27 November 2020

RESPONSE TO INFORMATION REQUEST - DEVELOPMENT APPLICATION FOR MULTIPLE DWELLINGS, RECONFIGURATION OF LOTS AND OPERATIONAL WORKS ON THE SITE COMMONLY REFERRED TO AS 108 LAMBERT STREET, KANGAROO POINT (COUNCIL REFERENCE: A005542190)

Figure 1 – Extract from DA15.0476 – 3D imagery of the proposal and existing adjacent developments

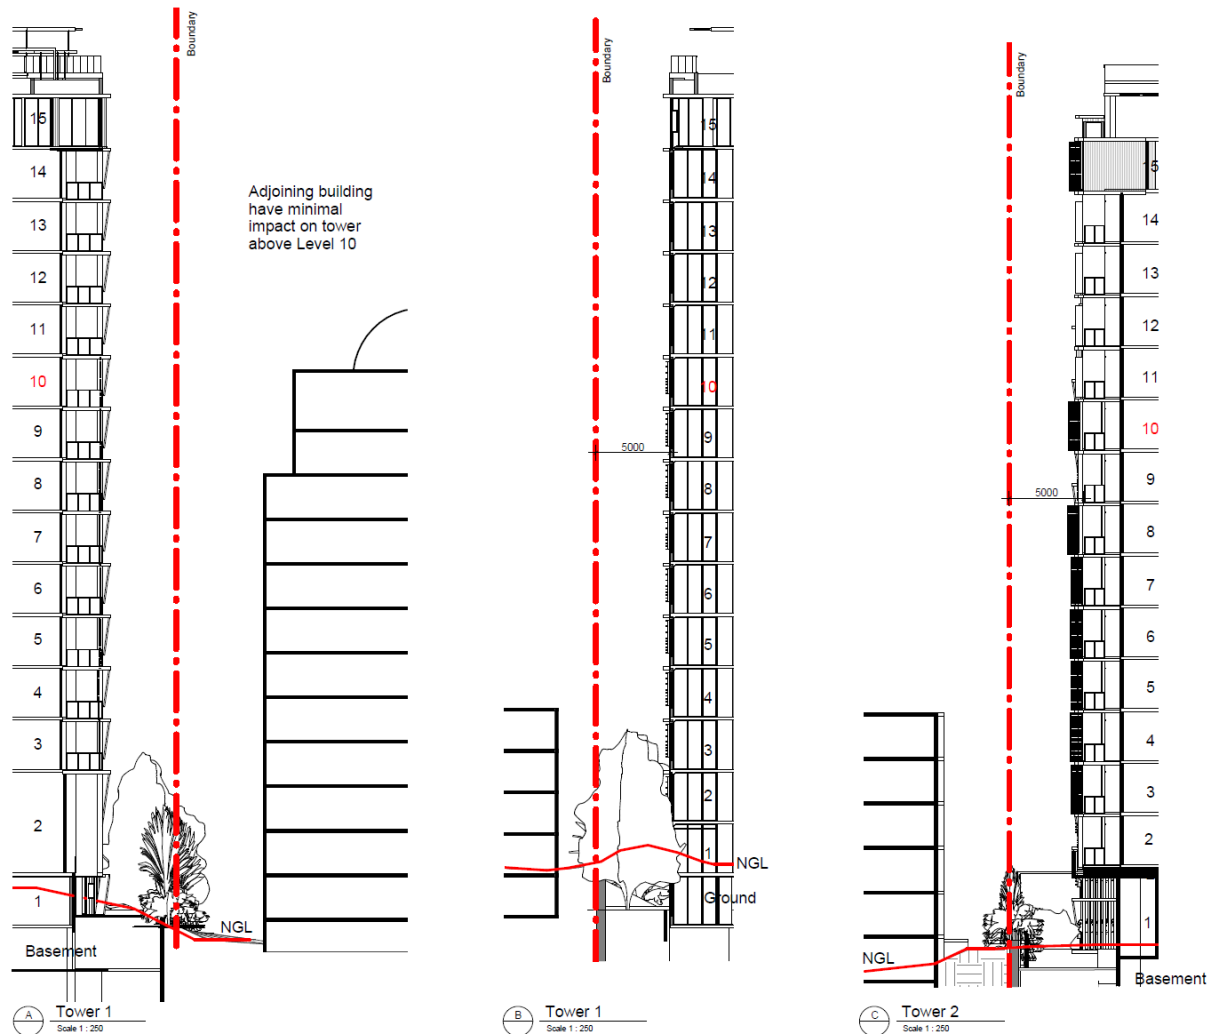
The proposal seeks performance outcomes for side boundary setbacks for Tower 1 and Tower 2, where not achieving a minimum side boundary setback of 6m to wall per AO3.1 of the Kangaroo Point Peninsula neighbourhood plan code.

Performance outcomes are also sought for building separation, where the proposed development does not achieve building separation in accordance with Table 7.2.11.1.3.F per AO3.2 of the neighbourhood plan code.

The justification detailed in the submitted assessment report (per PO3 of the Kangaroo Point Peninsula neighbourhood plan code) fails to adequately address amenity and privacy impacts and provision of light penetration and air circulation between buildings. The proposal has not been sited and designed to enable existing and future buildings to be well separated from each other.

- a) Revise the proposed plans to further increase side boundary setbacks and building separation distances. Provide a minimum 6m side boundary setback to wall for each of the proposed towers. Provide further increased building setbacks between Tower 1 and Tower 3, and Tower 2 and Tower 3, as well as separation to adjoining established buildings.*

Existing developments on adjoining sites do not exceed the tenth storey of the proposal and as such the additional 5 storeys proposed as part of this application are not expected to cause additional adverse and unacceptable amenity impacts with regards to light, air, privacy and air circulation. Refer to **Figures 1 and 2** below demonstrating the height of the proposal compared with adjacent developments, as well as the associated setbacks.

Figure 6 – Extract from DA15.0106 – Pedestrian access from O'Connell Street

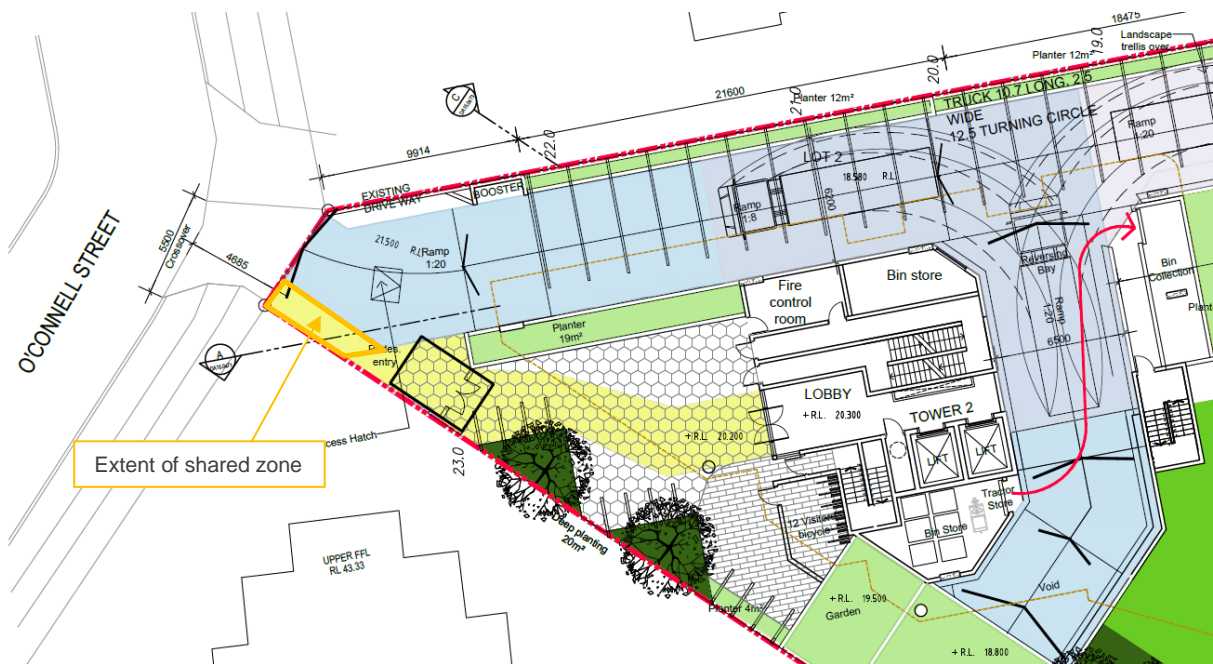
Given the constrained frontage width to O'Connell Street, further detail is required as to how potential conflicts between vehicle and pedestrian movements will be addressed to facilitate safe pedestrian access to the site. Landscape drawing SK002 indicates a site entry path separated from the vehicle crossover and trafficable surface, however this detail is not present on the corresponding architectural drawing (refer to Drawing 1786_DA15.0106 Rev D), for access to Tower 2. Furthermore, there does not appear to be step free/gradient appropriate access for pedestrians accessing Tower 1 from the Lambert Street frontage, which is not acceptable. A pedestrian path is to be 1.5m wide to comply with the provisions of the Transport, access, parking and servicing PSP.

On-street and off-street provision of pedestrian facilities associated with new development must achieve fair, safe and equitable access and mobility. The reliance on external stairs parallel to the access driveway presents mobility challenges to persons with reduced mobility.

- a) Provide revised drawings and documents which rationalise the pedestrian movement outcomes from both the Lambert Street and O'Connell Street frontages. Pedestrian movement is required to be safe, legible and delineated from trafficable surfaces per AO32.2/PO32 of the Multiple dwelling code.

Response: As requested by Council, revised drawings prepared by Kris Kowalski Architects (refer to **Attachment 1**) have been updated in yellow to clarify the pedestrian movement outcome for the development for both the Lambert Street and O'Connell Street frontages. It should also be noted that 1.5m annotations have been included as requested.

The 6m O'Connell Street frontage provides limited opportunity for separate pedestrian access, noting that a 6m driveway is required by Council. However, given the slow-speed environment, direct sightlines, and obvious pedestrian entryway, a shared zone of approximately 4.5m in length is considered an acceptable outcome and one that will not compromise safe or legible access for pedestrians to Tower 2. Refer to **Figure 6** below.
